# RETREAT AT TIMBERRIDGE FILING NO. 1

# CONSTRUCTION DRAWINGS

APRIL 2019

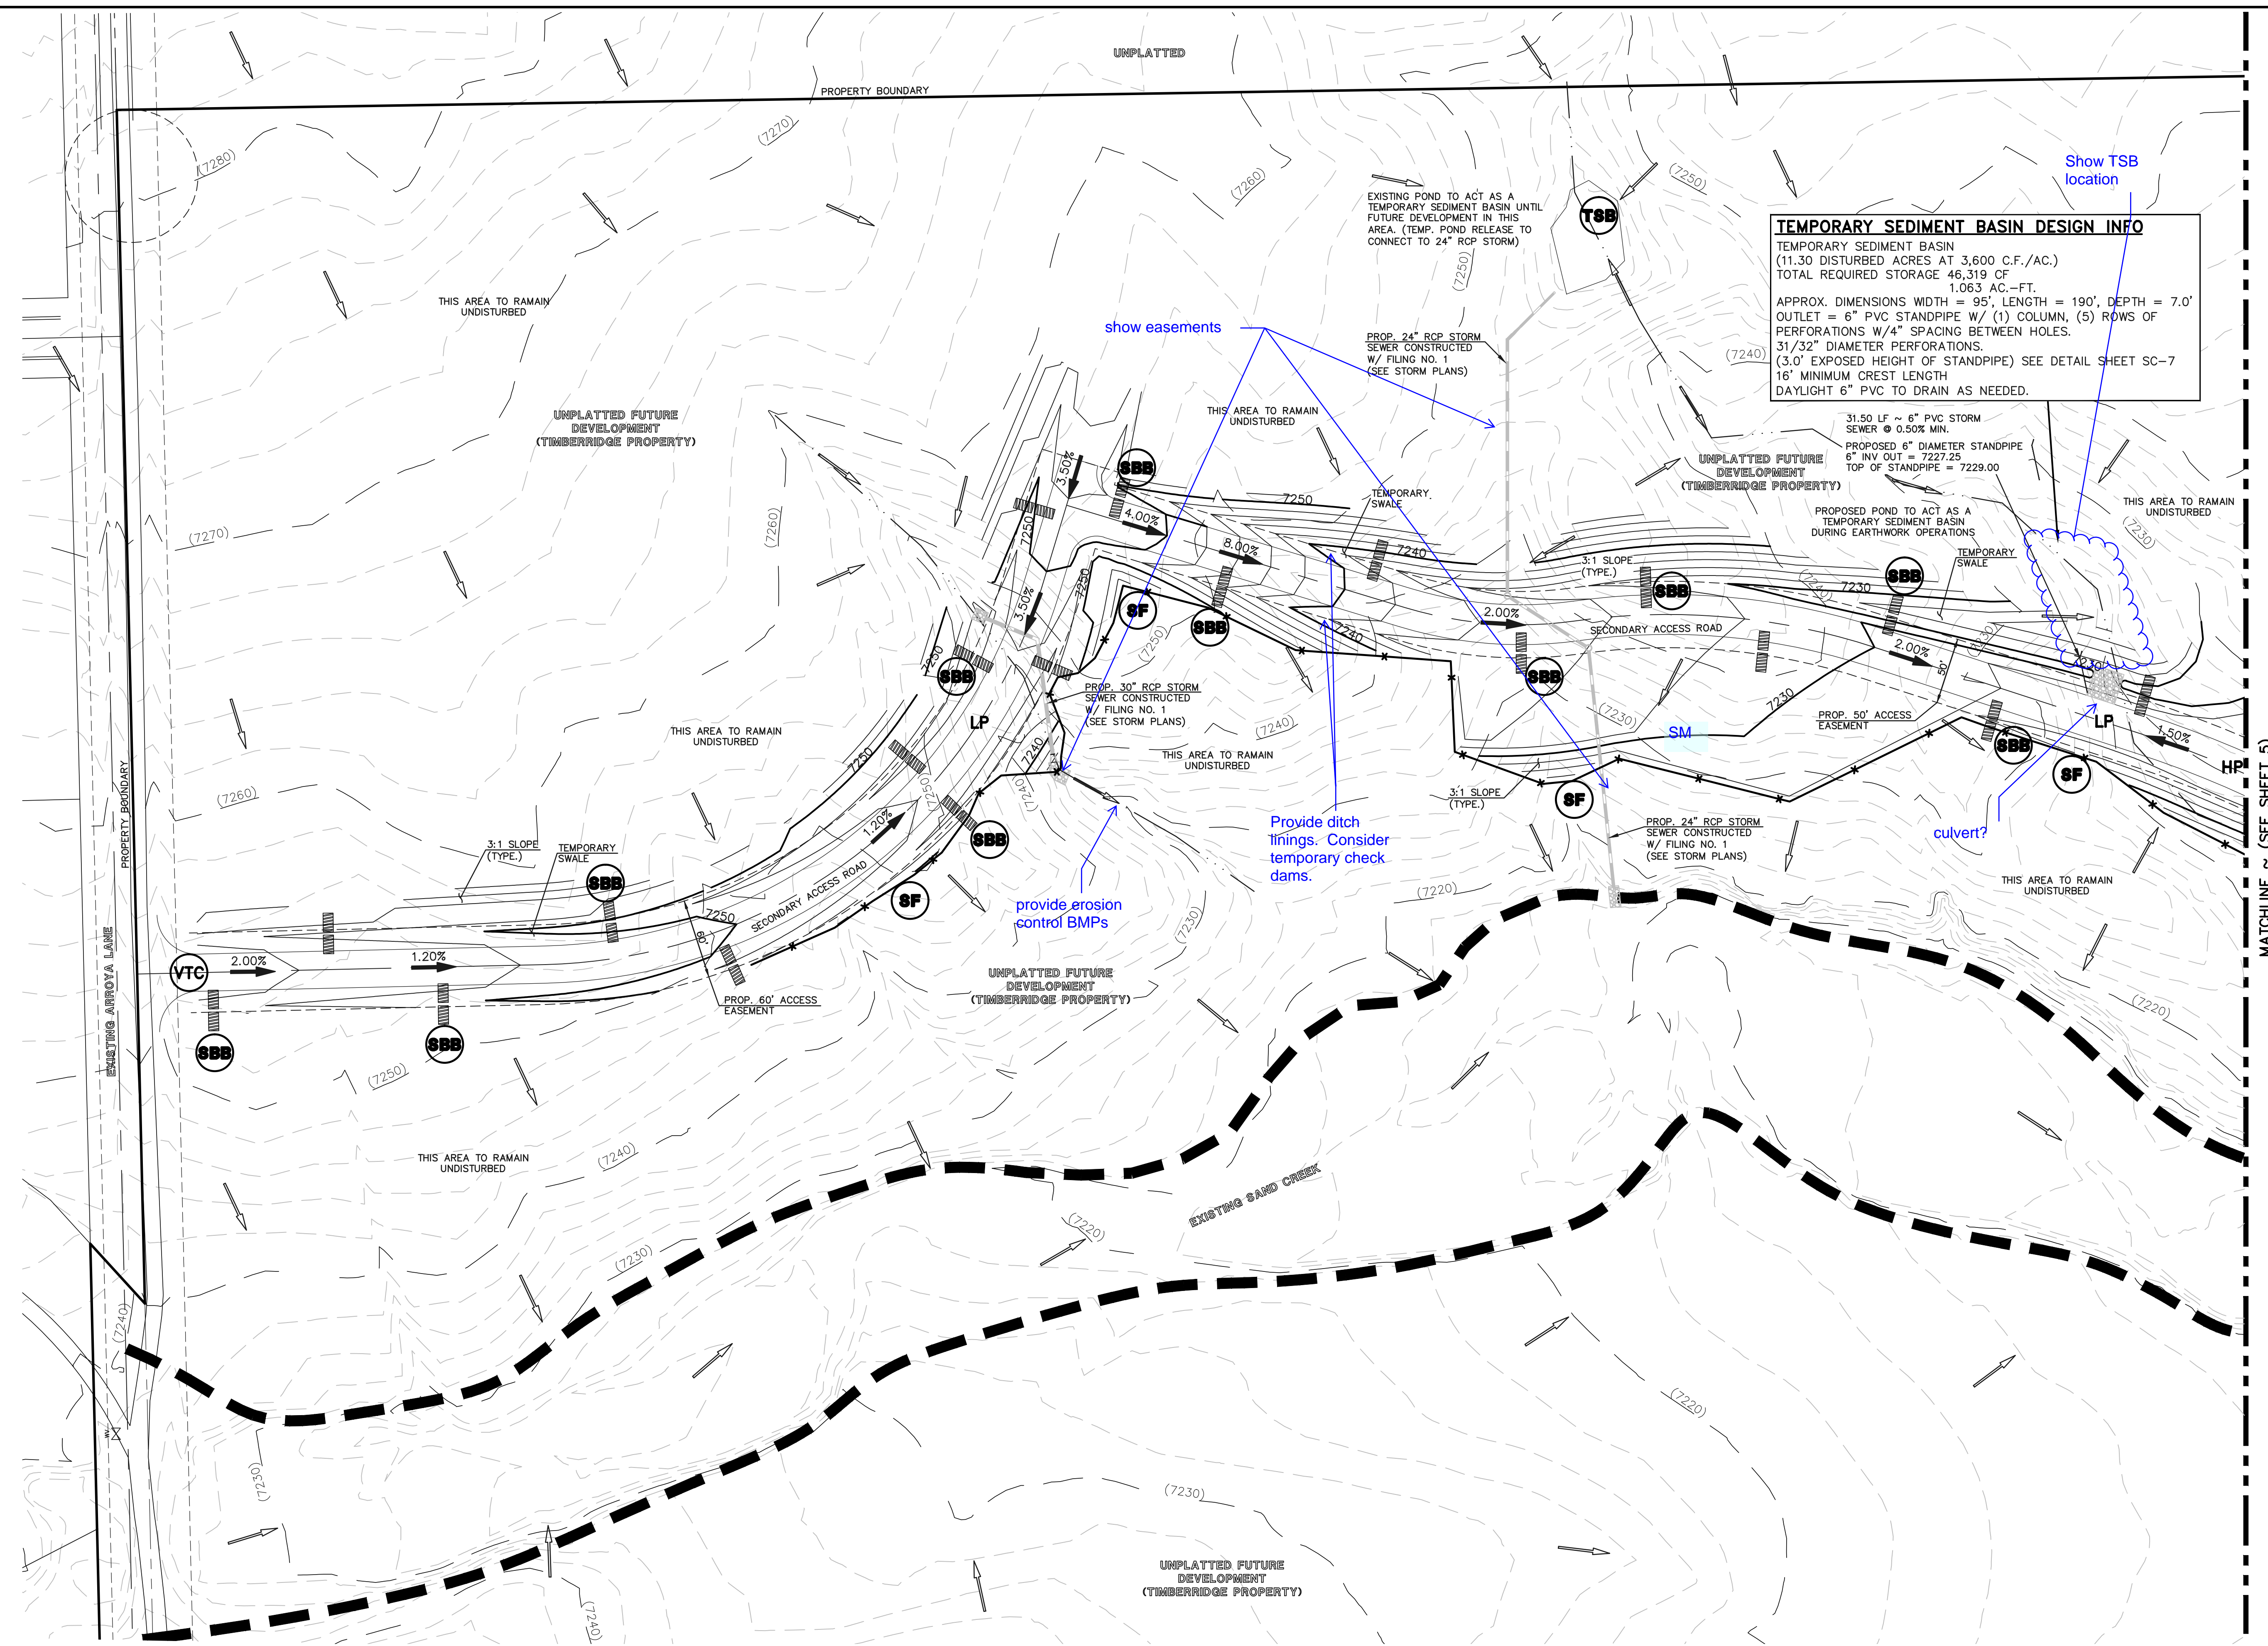
Provide channel plans.  
See FDR redlines.

provide TSB or  
check dams.

show limits of disturbance,  
seeding and mulching

RETREAT AT TIMBERIDGE FILING NO. 1 CONSTRUCTION PLANS STREET IMPROVEMENT PLANS POCO ROAD

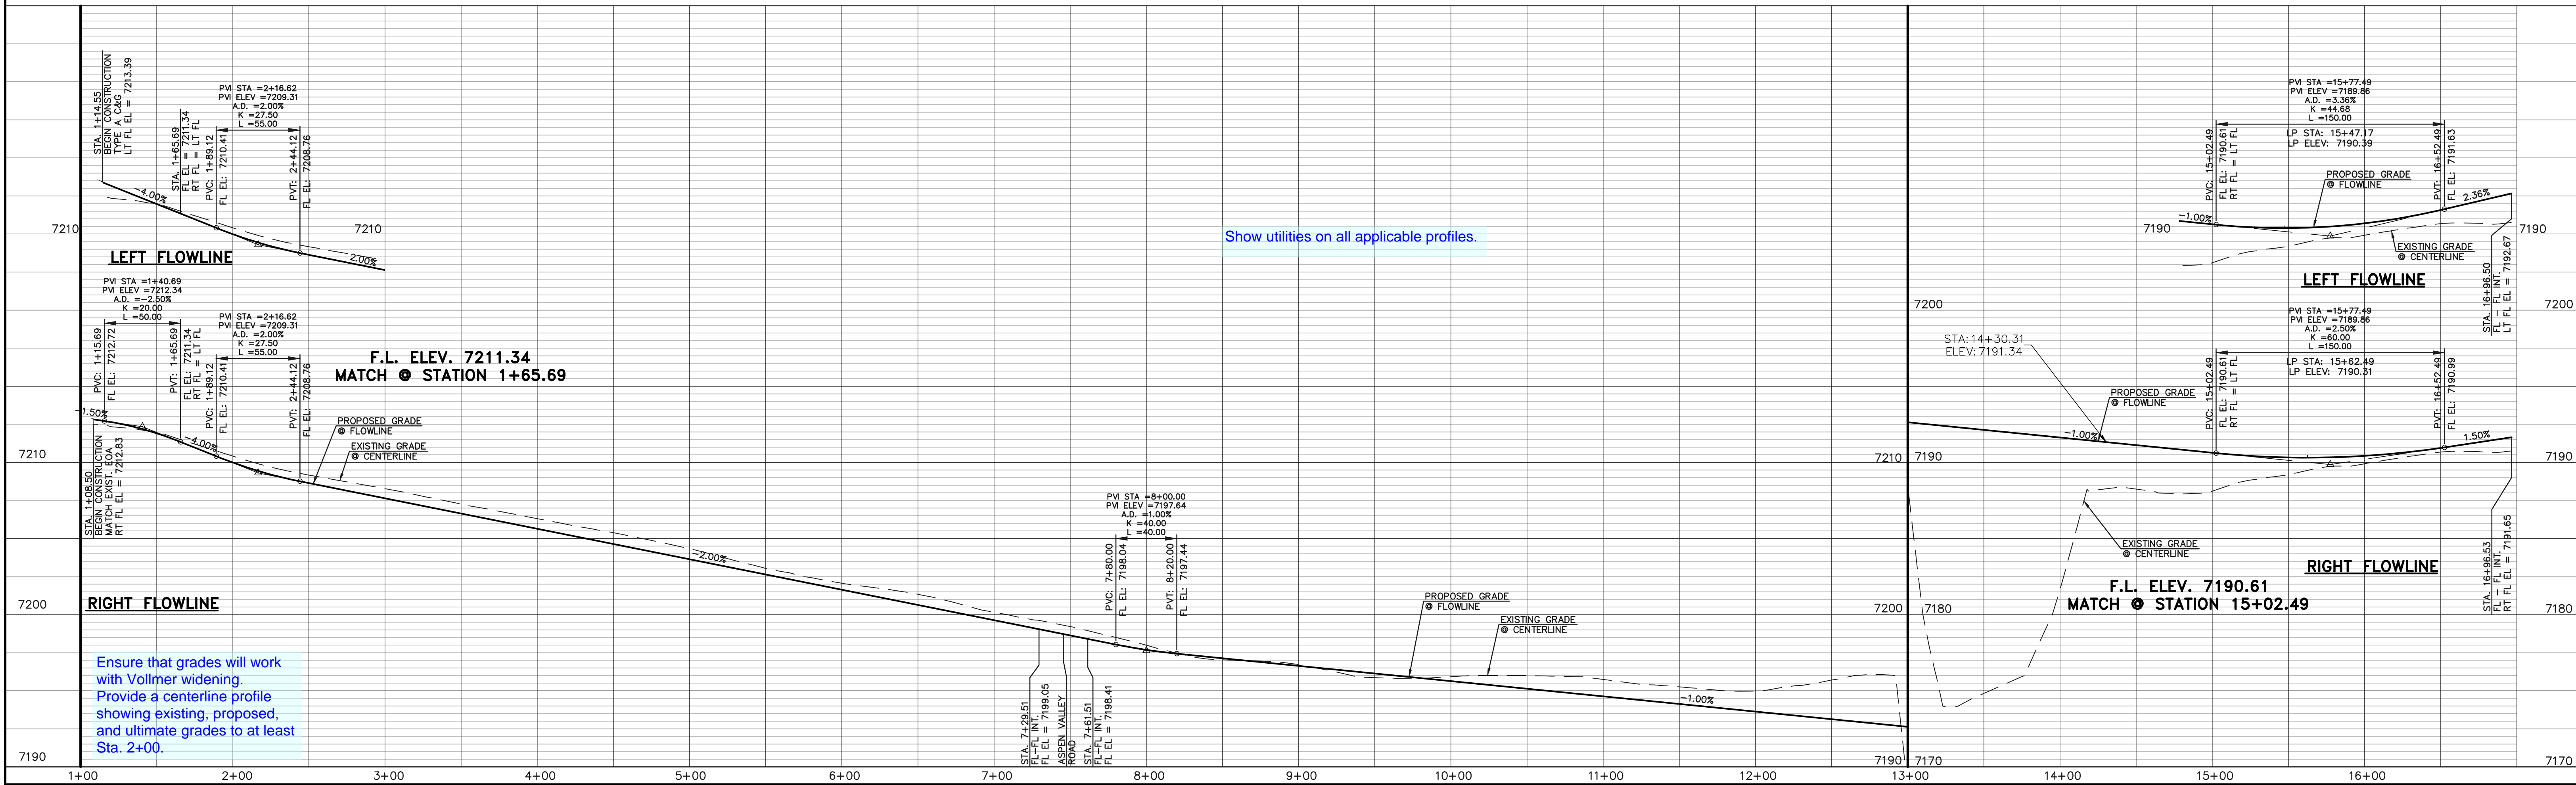
Provide CDOT std details. Reference [https://www.codot.gov/business/designsupport/standard-plans/copy\\_of\\_2012-m-standards-plans/2012-m-standards-pdfs/m-606-1\\_mgs\\_type\\_e\\_3\\_w-beam/m-606-1-mgs-type3-w-beam](https://www.codot.gov/business/designsupport/standard-plans/copy_of_2012-m-standards-plans/2012-m-standards-pdfs/m-606-1_mgs_type_e_3_w-beam/m-606-1-mgs-type3-w-beam) and [https://www.codot.gov/business/designsupport/standard-plans/guardrail-faq/at\\_download/file](https://www.codot.gov/business/designsupport/standard-plans/guardrail-faq/at_download/file)

Provide Vollmer Road dimensions and adequate improvements north and south of intersection to meet criteria.

Delete ramp?

Show utilities on all applicable profiles.

Ensure that grades will work with Vollmer widening. Provide a centerline profile showing existing, proposed, and ultimate grades to at least Sta. 2+00.

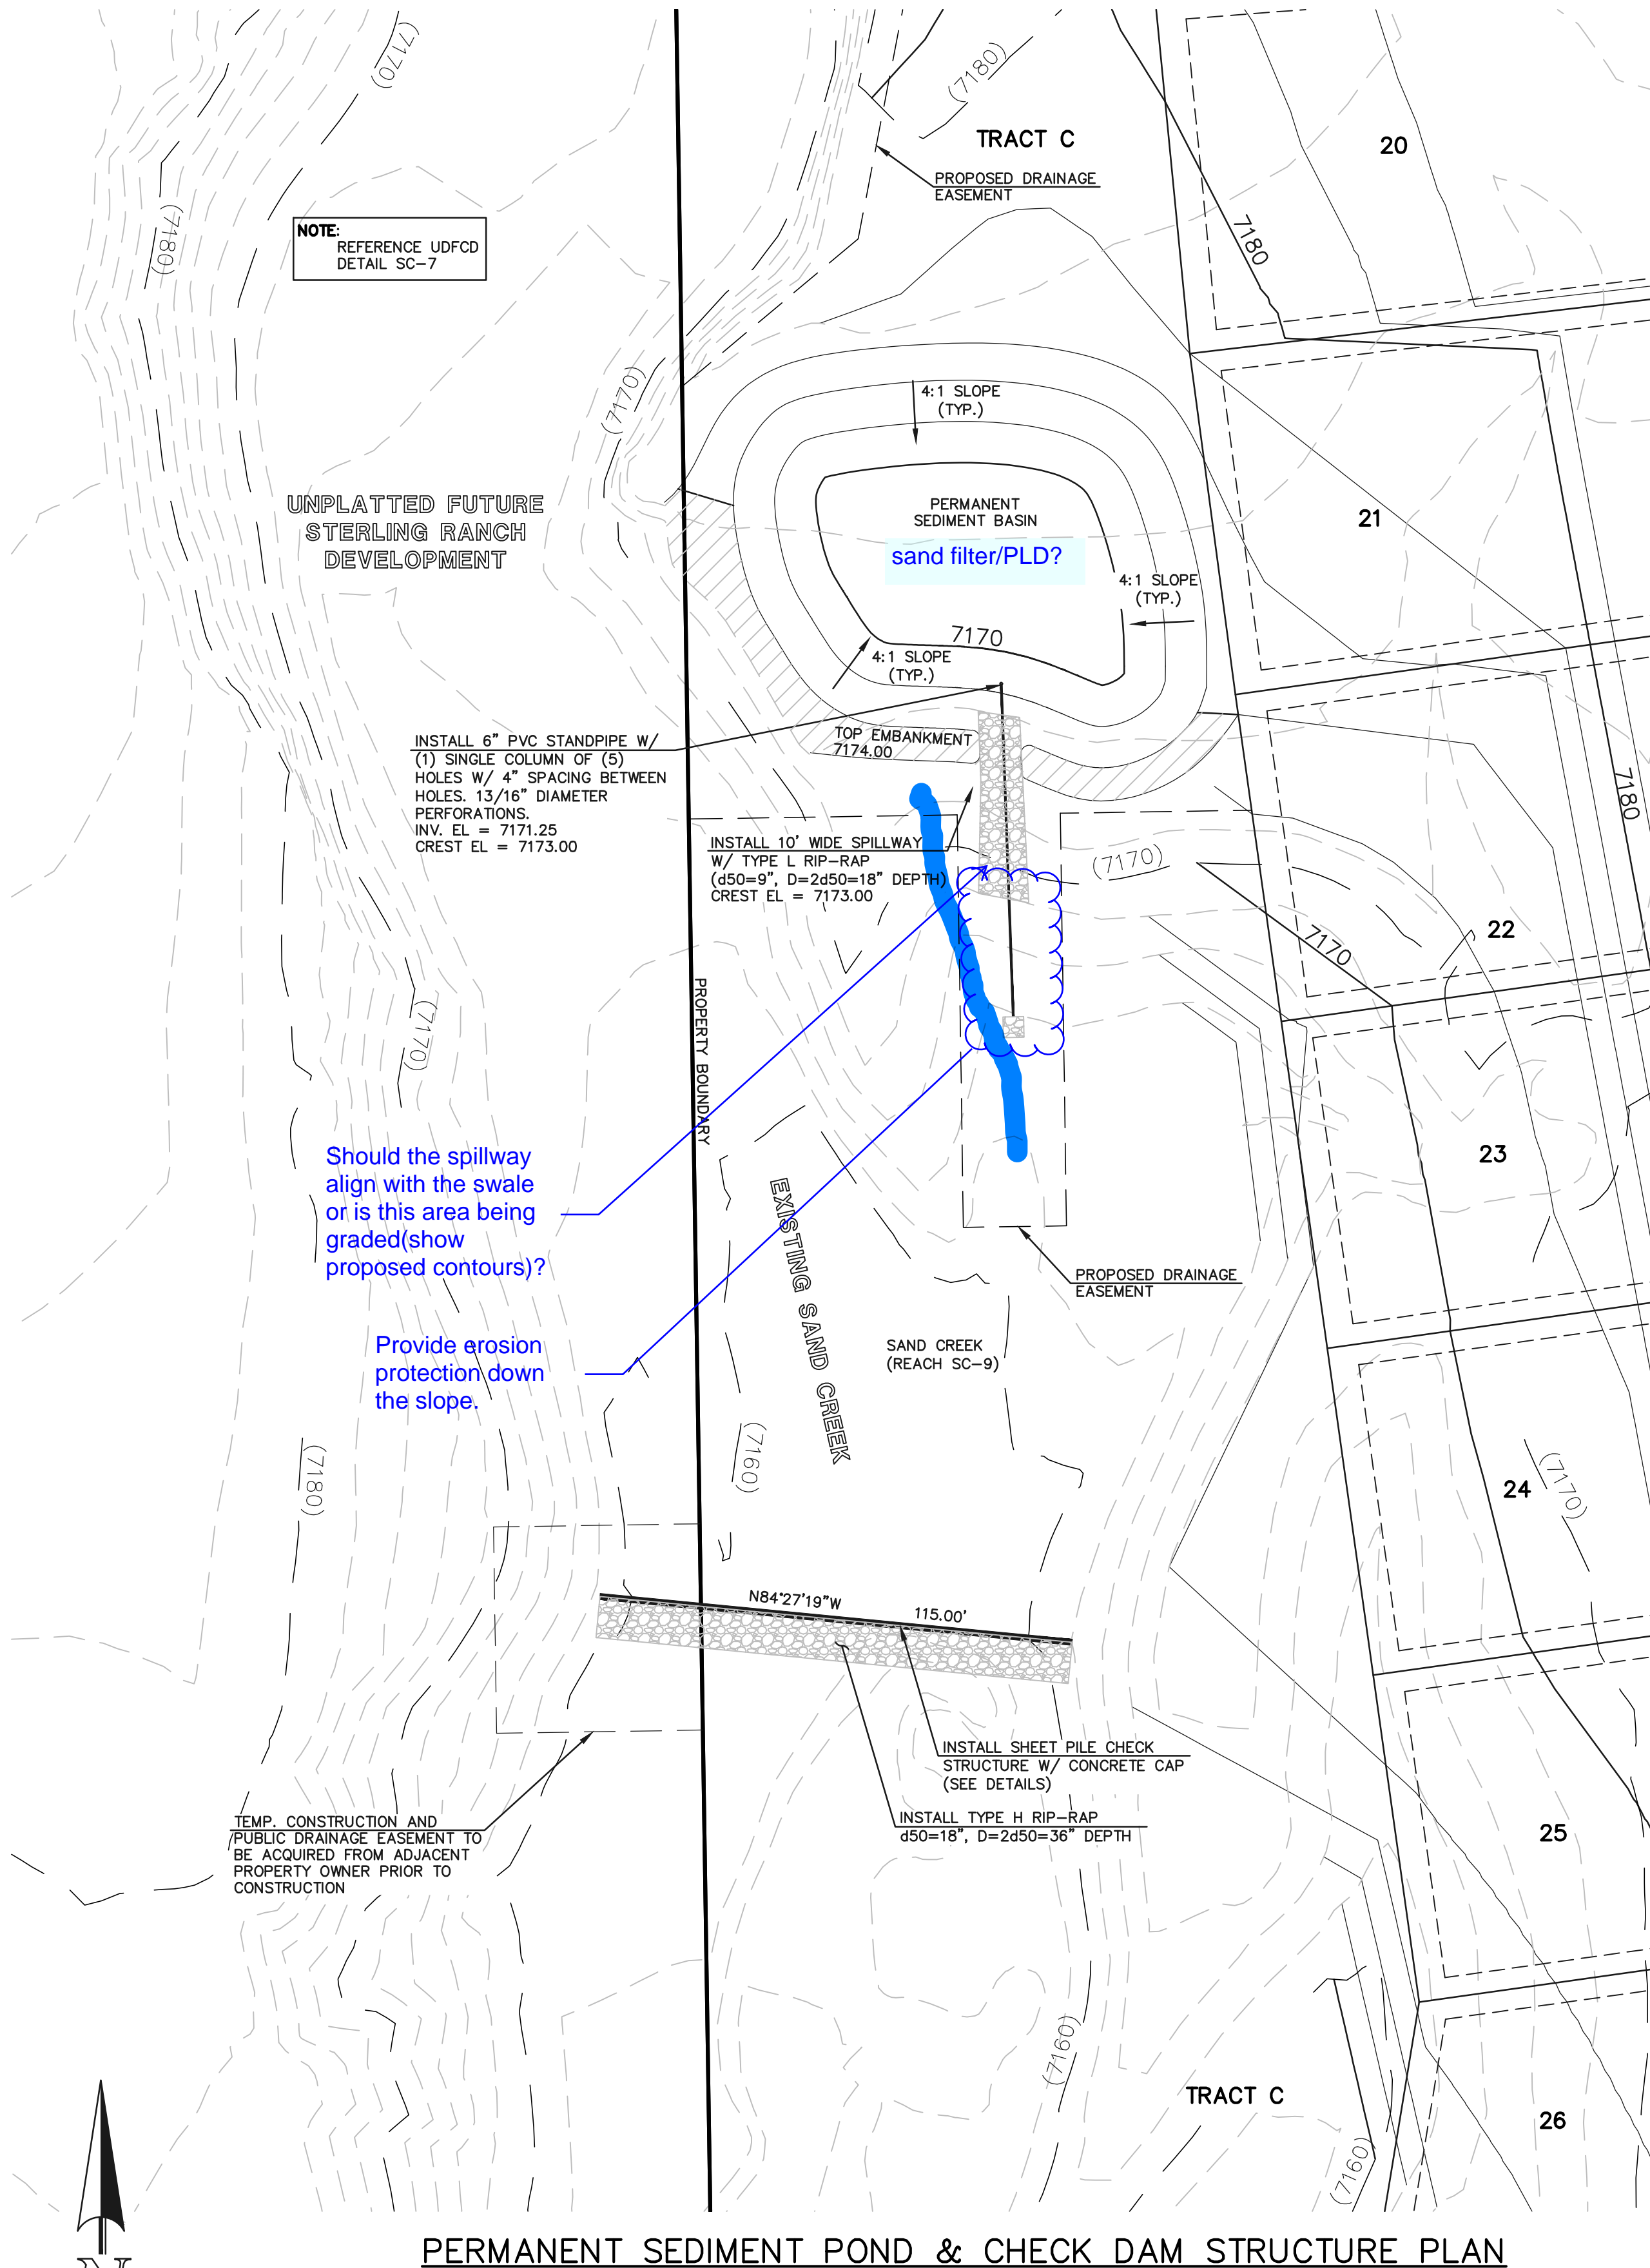
Should the spillway align with the swale or is this area being graded (show proposed contours)?

Provide erosion protection down the slope.

Provide channel plan and profile and actual cross-sections.
